**CITY OF SOUTHPORT
PLANNING BOARD
REGULAR MEETING AGENDA**

MAJOR SITE PLAN APPLICATION

Re: Technical Review Committee Review – Major Site Plan Review – J Swain/Eason Streets Commercial Development

The Shoppes at Dutchman Village

Sheet No:
C200

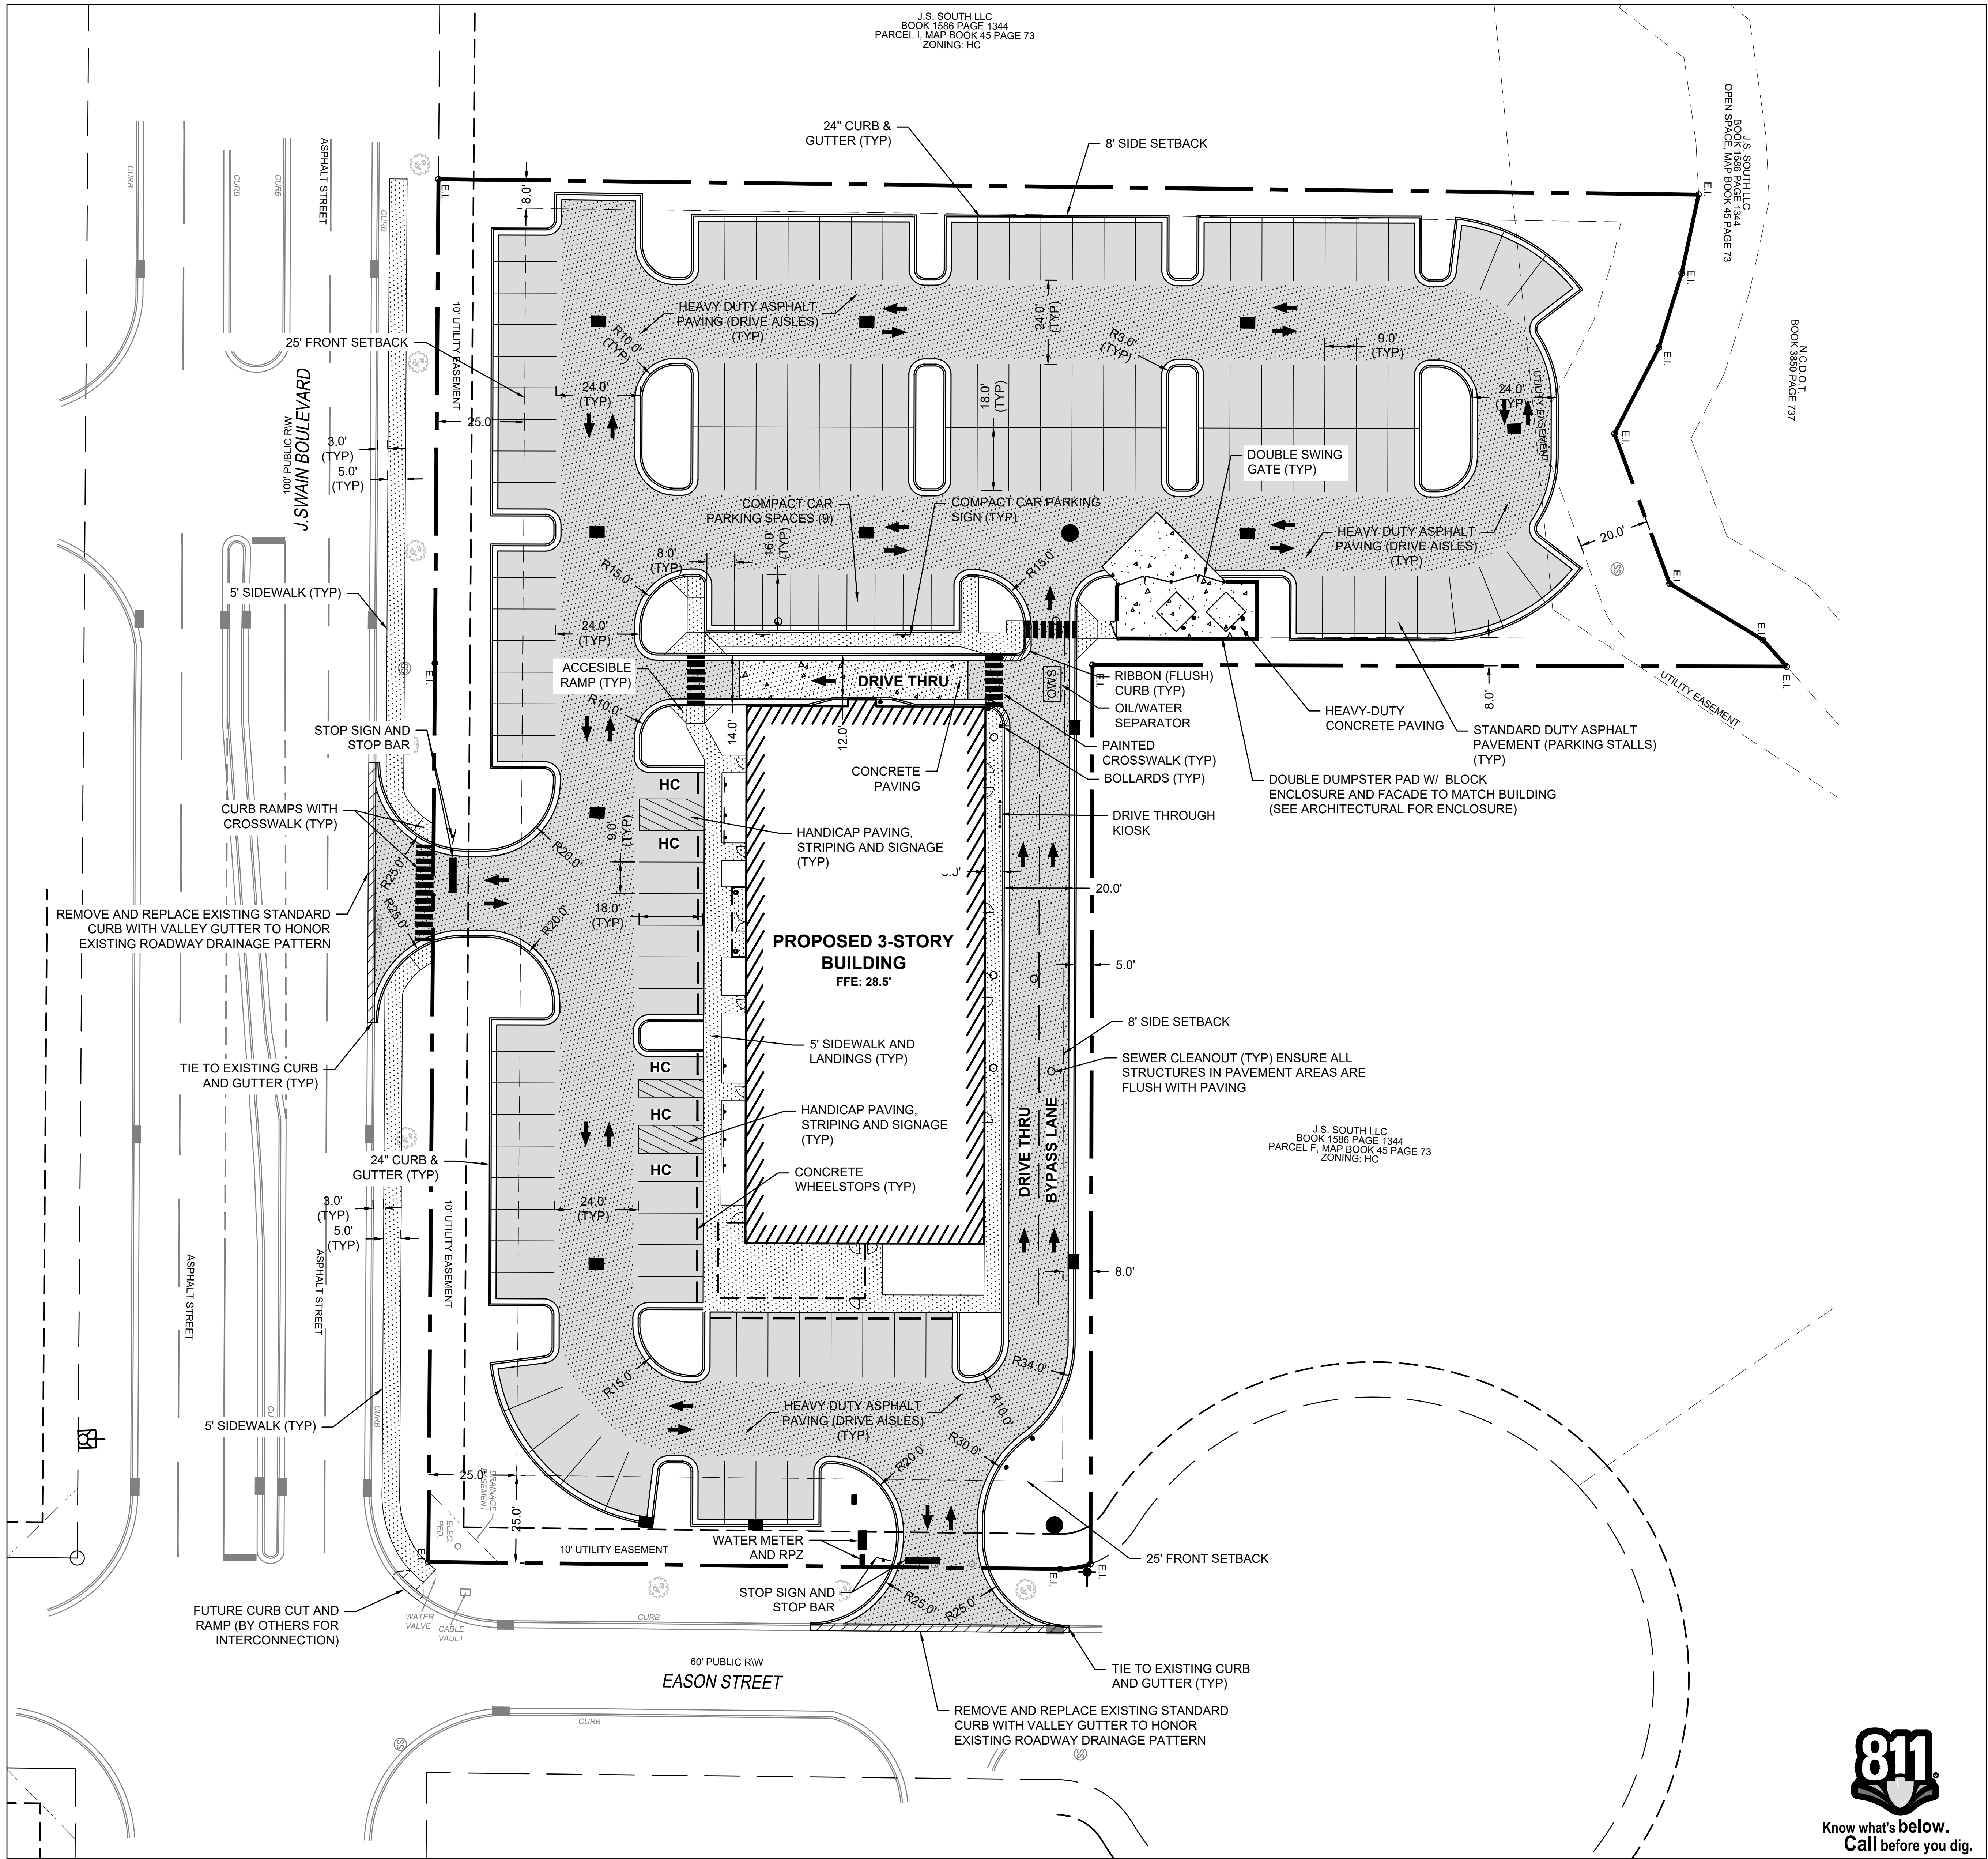
For building height, a finished floor elevation of 27.5 feet is noted on sheet C200, and the maximum height of 40 feet in the HC, Highway Commercial zoning district is correctly noted multiple times in site notes on multiple pages. However, Appendix A of the Unified Development requires proposed building height be demonstrated on proposed site plan. Building height shall be reviewed further at the time at which building permits are reviewed.

Based upon the standards laid out in Section 3.14.D and Table 3.4, minimum parking requirements are based upon the square footage of the various uses proposed. Minimum parking requirements for this proposal are the following, as also shown in Site Data Note #10 on page C200 of the submitted site plan:

2.5 Consistently describe land use descriptions of proposed uses for building on all sheets (for example, sheet C200 vs. sheet C600, within site data tables).

Current MB and PG numbers have been added to the plans. Please note recombination is in progress and parcel information will be revised. (Note #3, Site Data Table, Sheets C200 & C600)

Note added to Sheet C200 stating signage requirements. (Note #16, General Sheet Notes)

Lighting Plans is in progress by BEMC. Note has been added to Sheet C200 stating lighting requirements. (Note #17, General Sheet Notes)

Sheet No:
C600

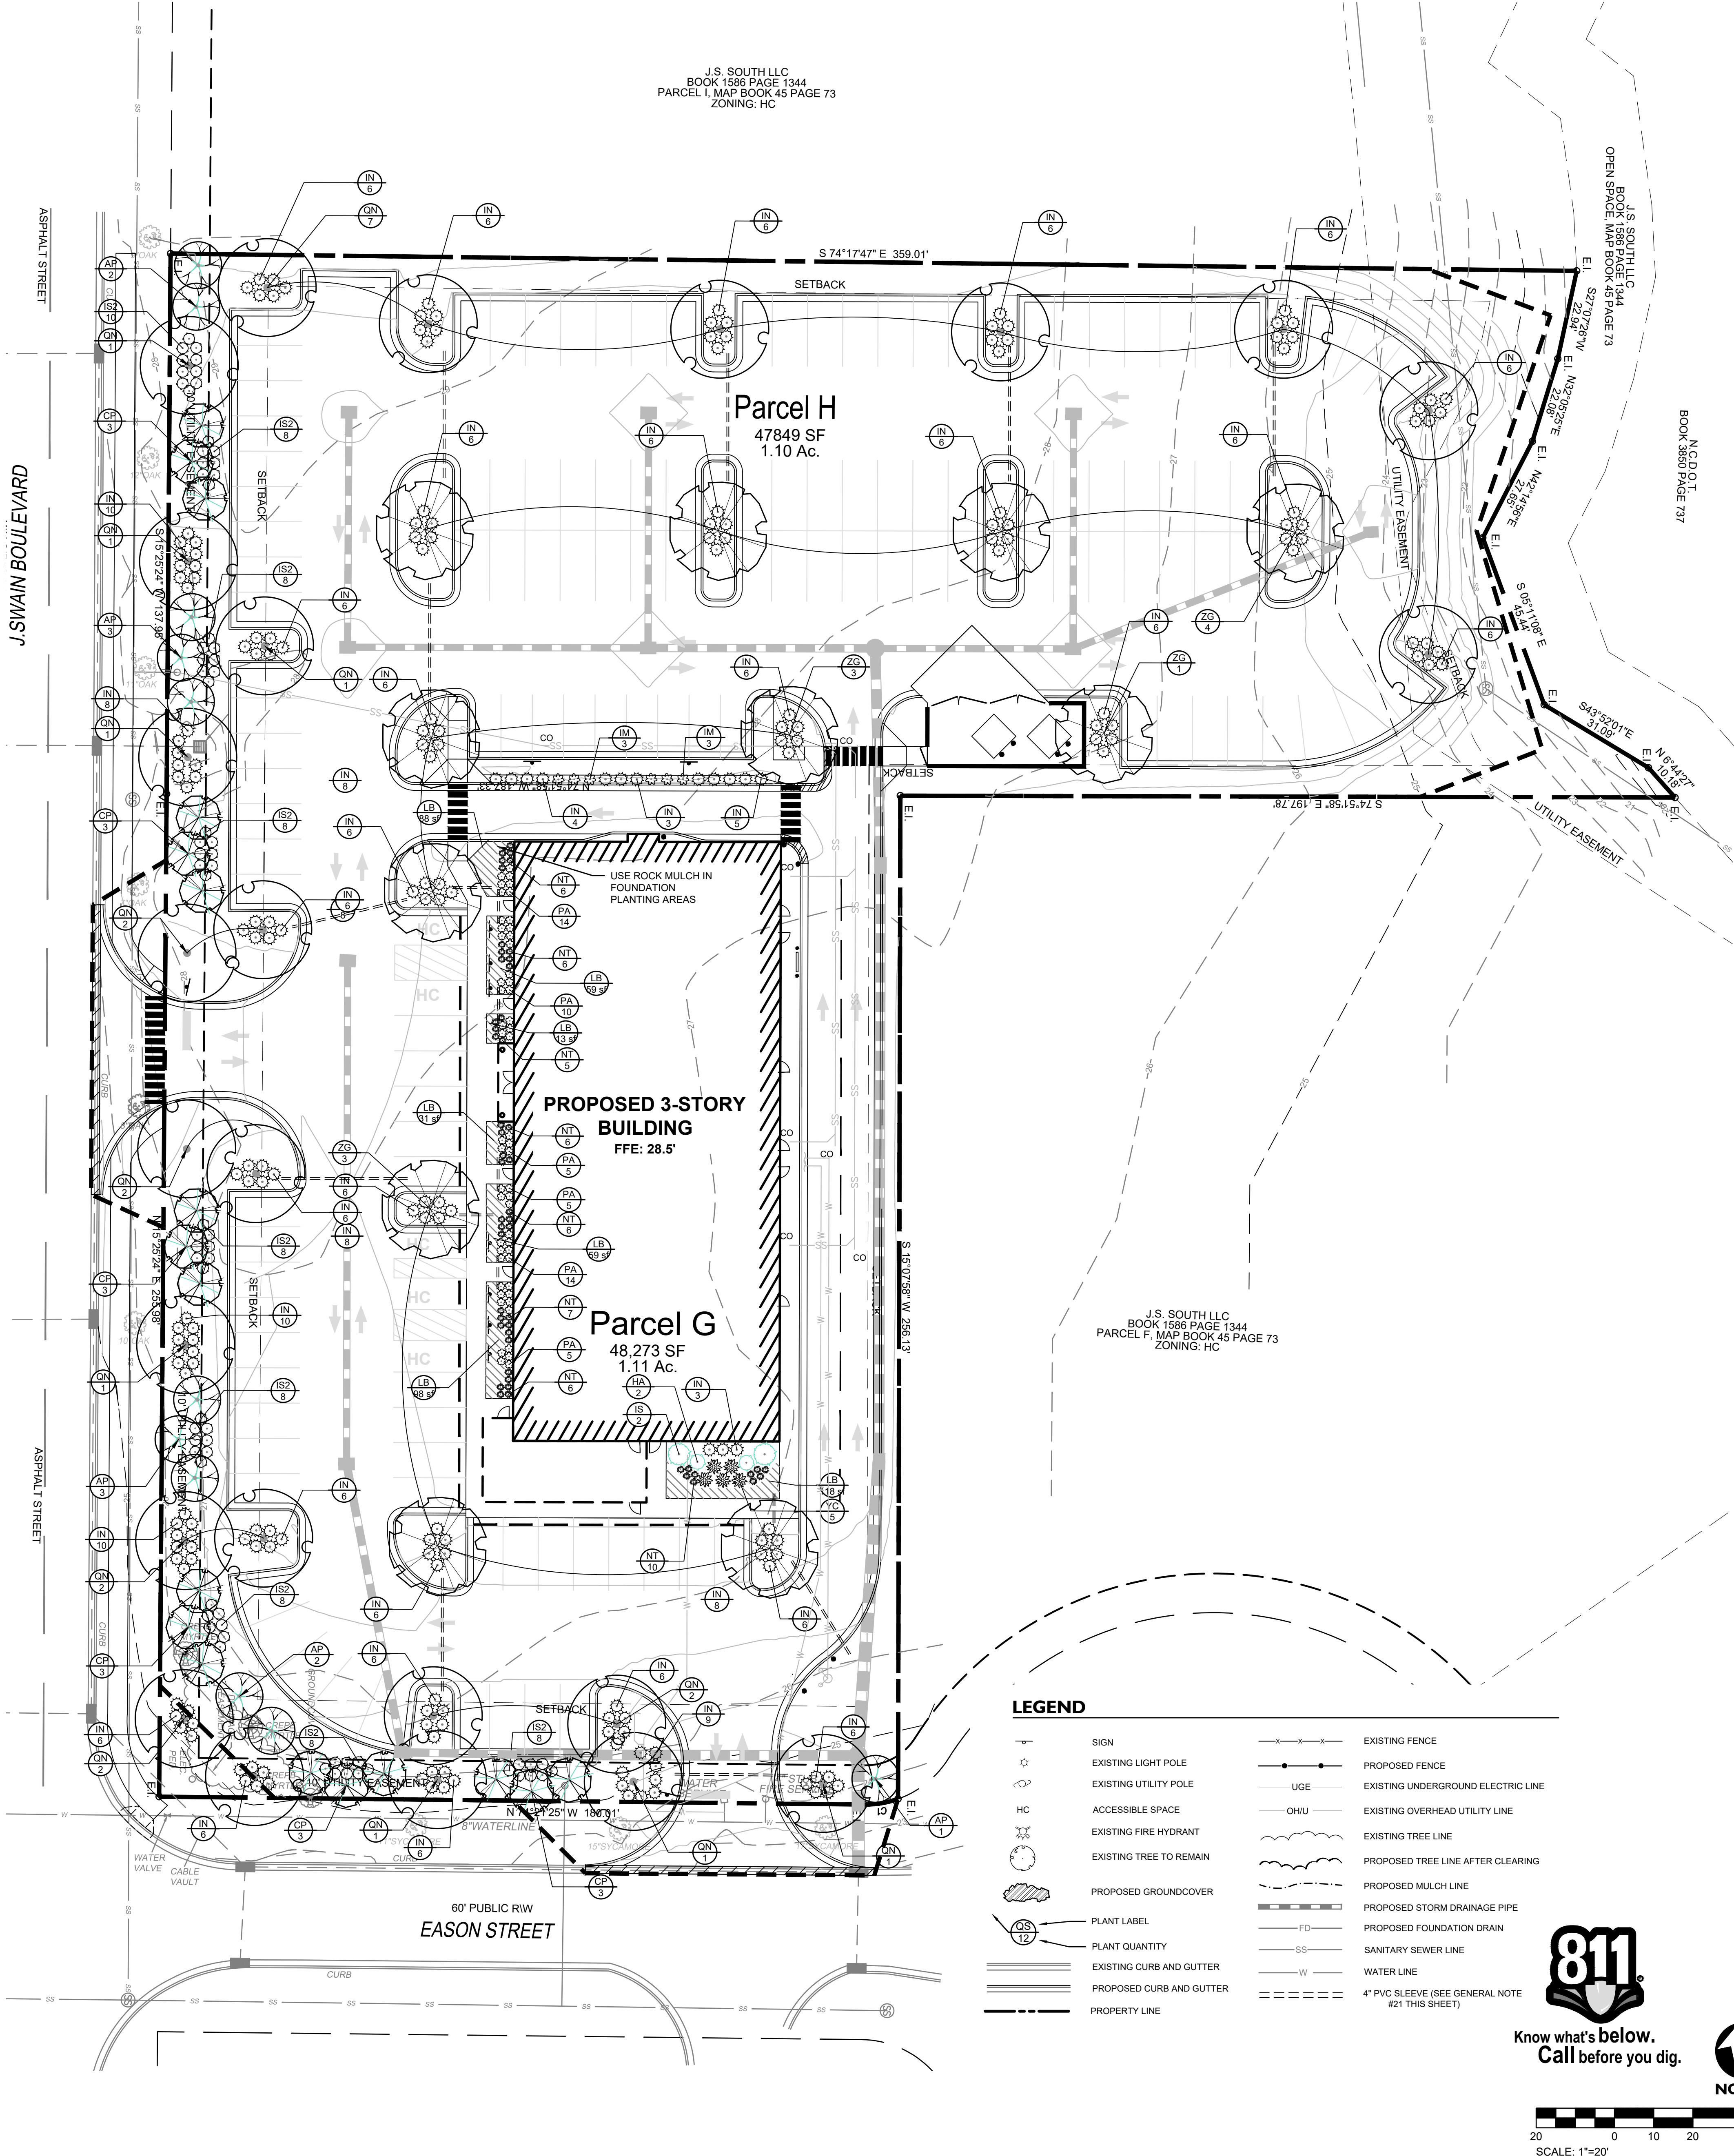
All street yards and parking facility landscaping shall be in accordance with Sections 3.17.F and 3.17.G. Staff has found that based on dimensional requirements with regard to the location and amount of required canopy and understory trees as well as shrubs, the submitted site plan is in conformance with the applicable standards. However, as noted within the attached TRC comments, Staff have noted inconsistencies between the submitted site plan and the listed planting options as laid out in Tables 3.5, 3.6, and 3.7, and have requested that the applicant correct those inconsistencies.
